CITY OF OCEANSIDE  
DEVELOPMENT SERVICES DEPARTMENT /  
PLANNING DIVISION

Subject: Application Review Committee (ARC), RD24-00002, Development of an SB330 - 8-story mixed-use development to include 272 multifamily dwelling units and 4,006 sq.ft. commercial. 28 units (10%) will be deed restricted lower income units.

(Parent) Project Number: RD24-00002  
Project Name: 901 Mission 8 story mixed use  
Project Planner: Nathalie Vazquez

**Subject:** Preliminary PDP SWQMP for 901 Mission Avenue (RD24-00002) – 1<sup>st</sup> Entitlement Review (PC1) for Development Plan

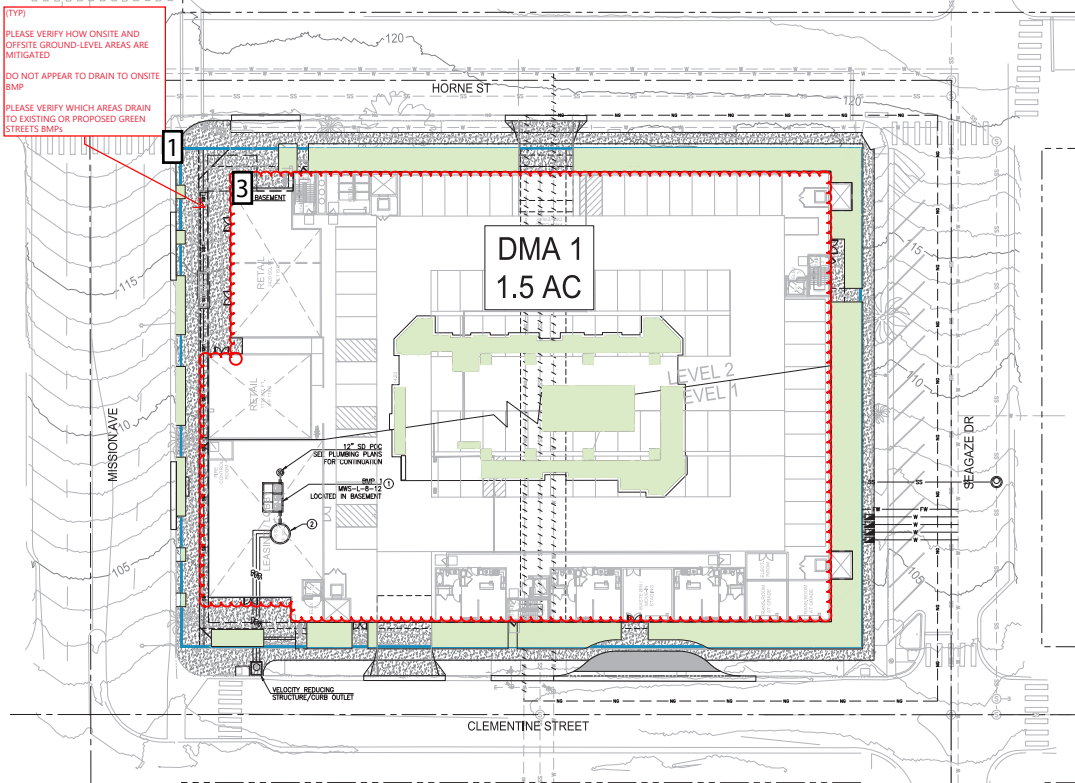
PLEASE IDENTIFY PLANNED LOCATION

(TYP)  
PLEASE VERIFY HOW ONSITE AND OFFSITE GROUND-LEVEL AREAS ARE MITIGATED  
DO NOT APPEAR TO DRAIN TO ONSITE BMP  
PLEASE VERIFY WHICH AREAS DRAIN TO EXISTING OR PROPOSED GREEN STREETS BMPs

**ATTACHMENT 4**  
**Copy of Plan Sheets Showing Permanent Storm Water BMPs**

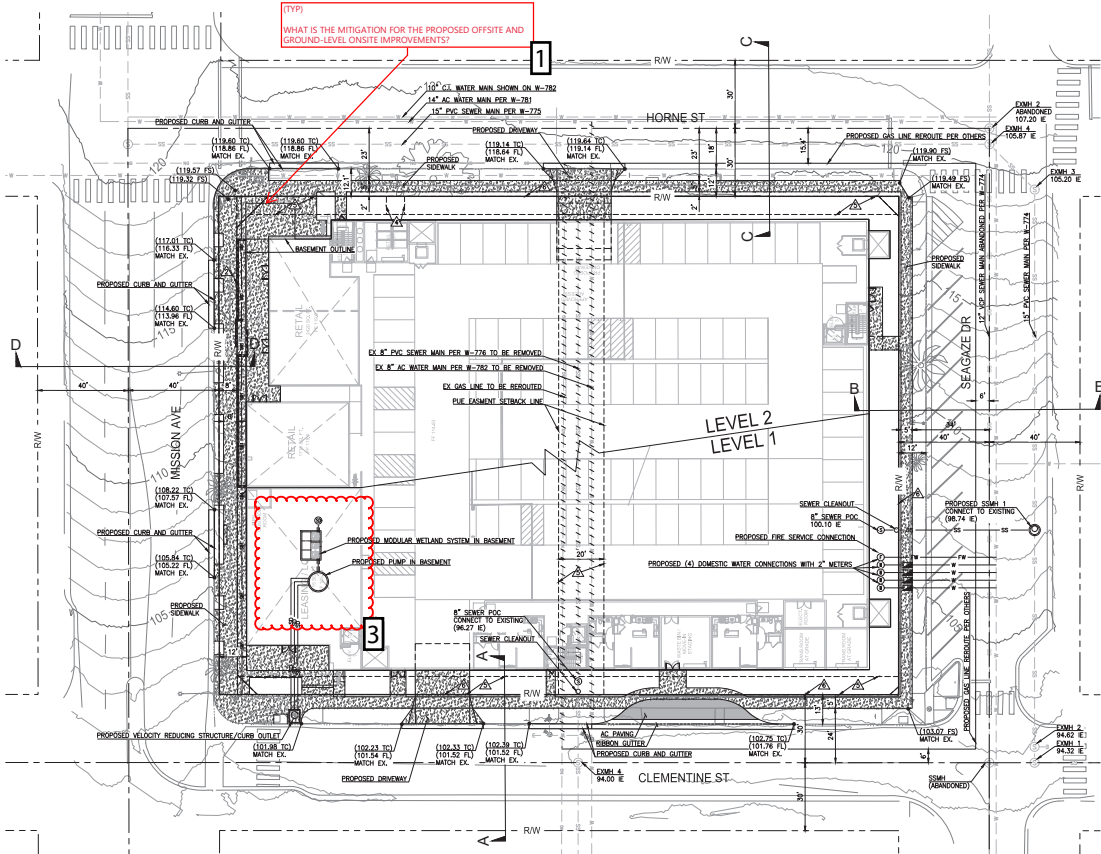
(TYP)  
WHAT IS THE MITIGATION FOR THE PROPOSED OFFSITE AND GROUND-LEVEL ONSITE IMPROVEMENTS?

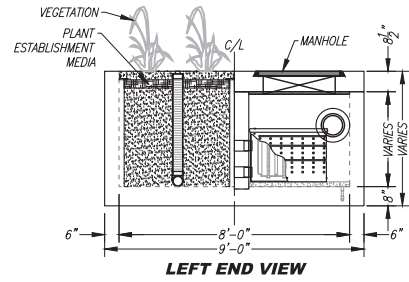
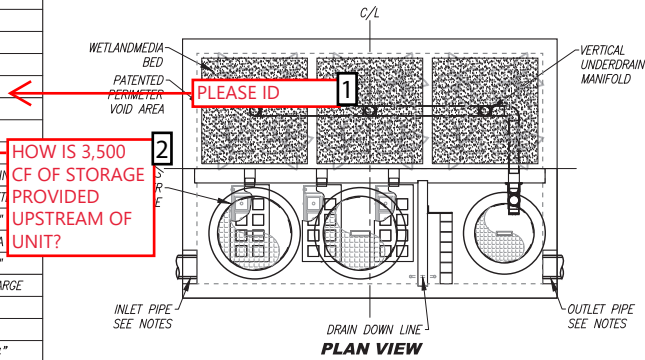
## WHAT IS THE MITIGATION FOR THE PROPOSED OFFSITE AND GROUND-LEVEL ONSITE IMPROVEMENTS?

☁ Number: 2 Author: Alex Subject: Polygon Date: 6/20/2024 5:03:33 PM  
PLEASE DEPICT PROPOSED GREEN STREETS FEATURES ON TYPICAL SECTIONS

☁ Number: 3 Author: Alex Subject: Polygon Date: 6/20/2024 5:06:54 PM  
PLEASE PROVIDE ADDITIONAL PRELIMINARY DETAILS WITH RESUBMITTAL

**MWS-L-8-12-V**  
STORMWATER BIOFILTRATION SYSTEM  
STANDARD DETAIL

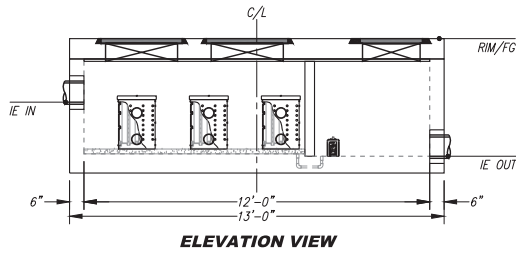
- 1.12. Please clarify if the proposed proprietary biofiltration BMP will be configured as a flow-based or volume-based system. The supporting calculations indicate the former, but the provided detail indicates the latter. If detention is needed, it would likely follow that a volume-based configuration would be desired.

C1.0

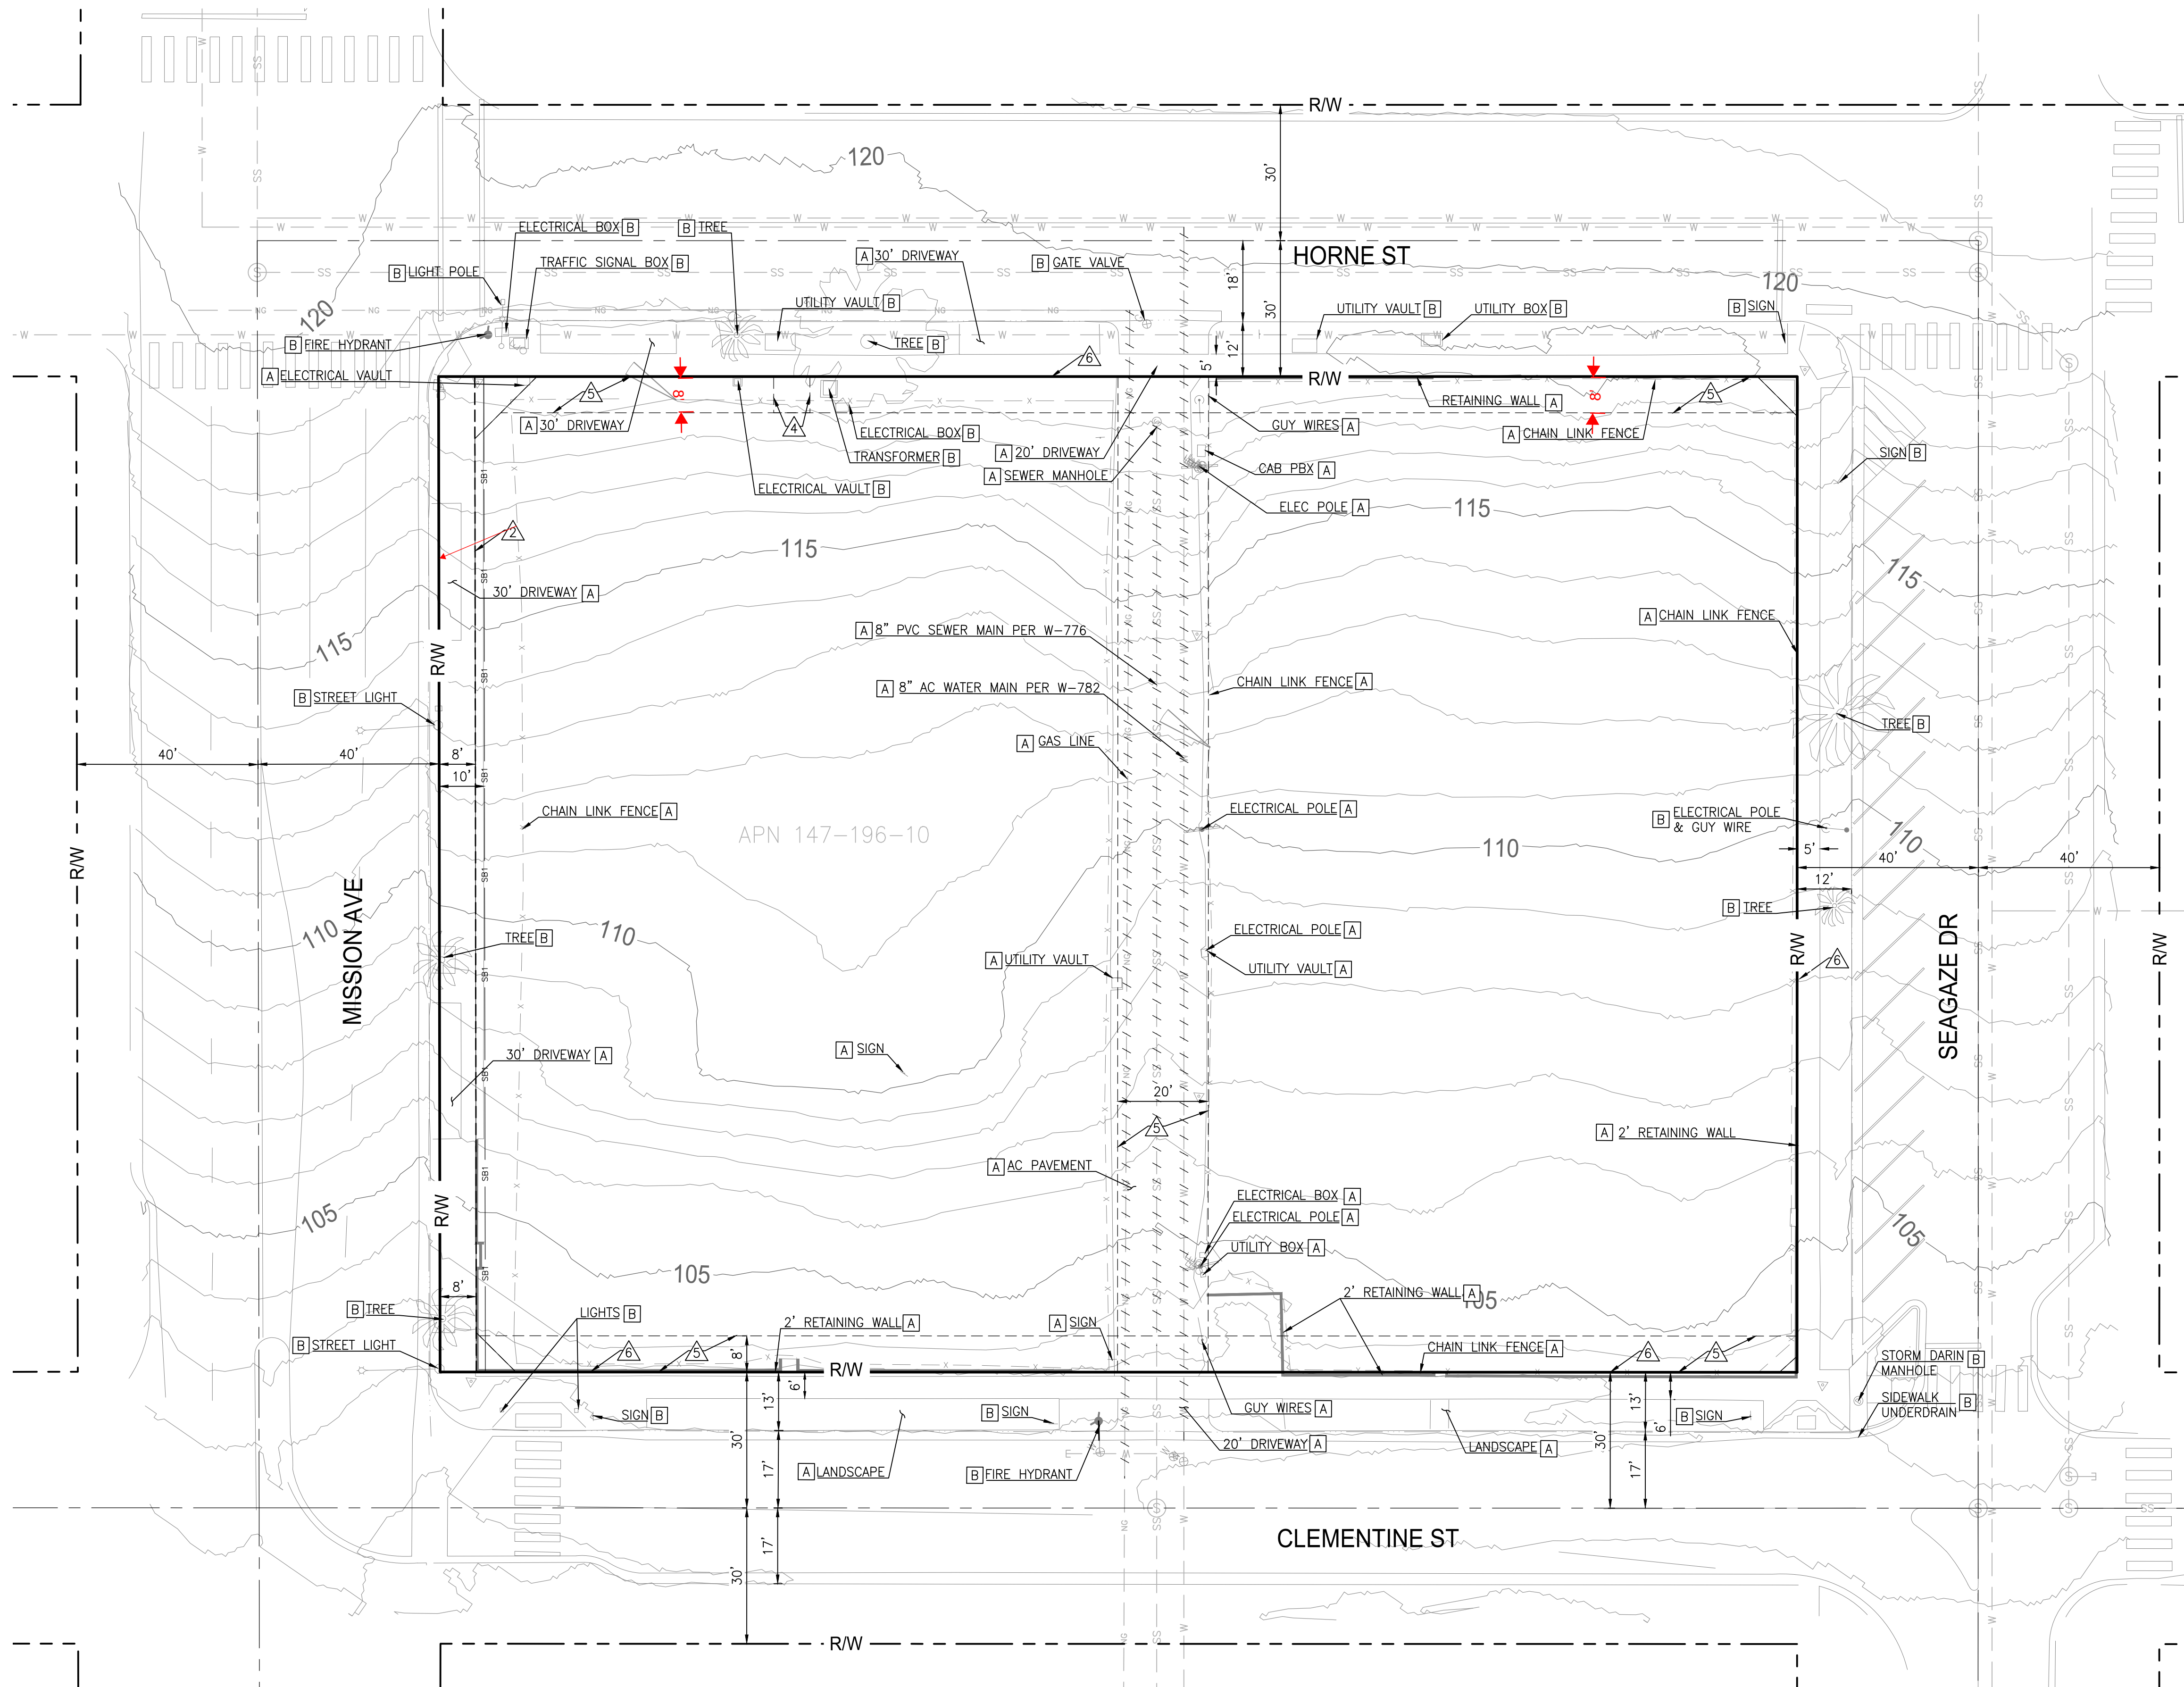
SEE COMMENTS ON SHEET C1.0

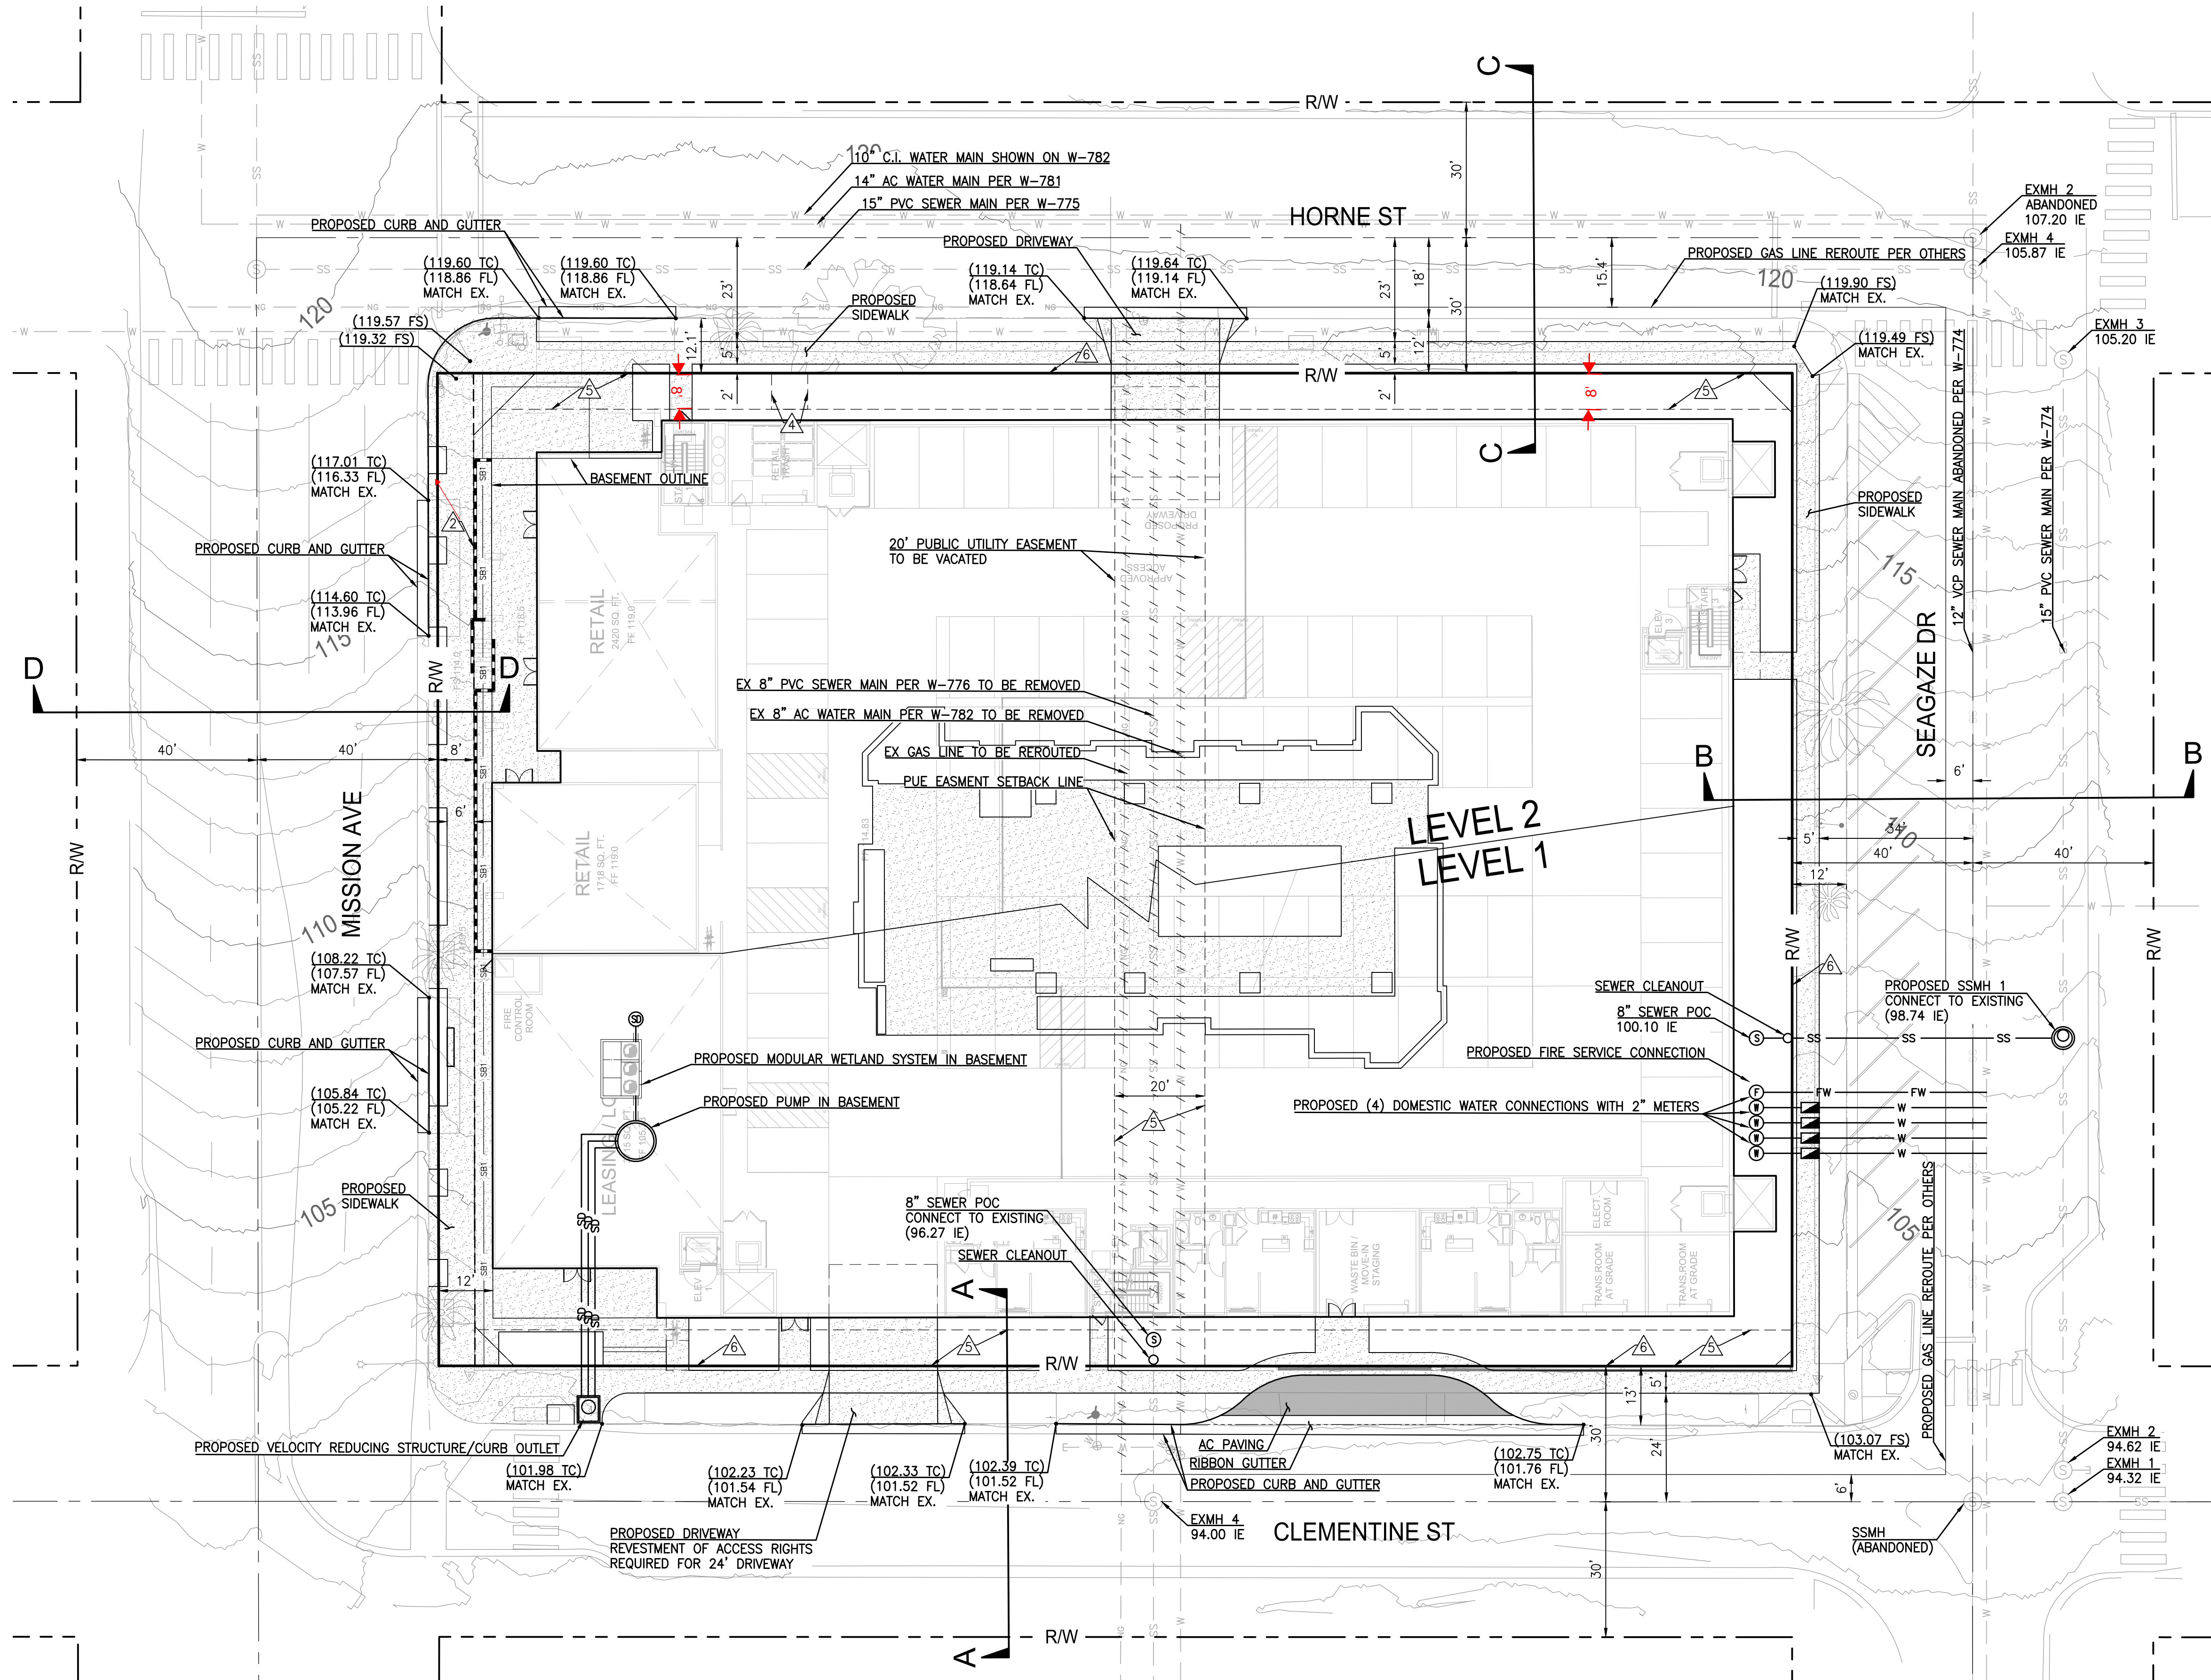
1. Development Plan:
  - a. C4.0 – note that the driveway off of Horne shall be 24 feet wide
  - b. A1.0 to A2.1 - show 2-foot clearance for stalls adjacent to a wall (at the end of an aisle)
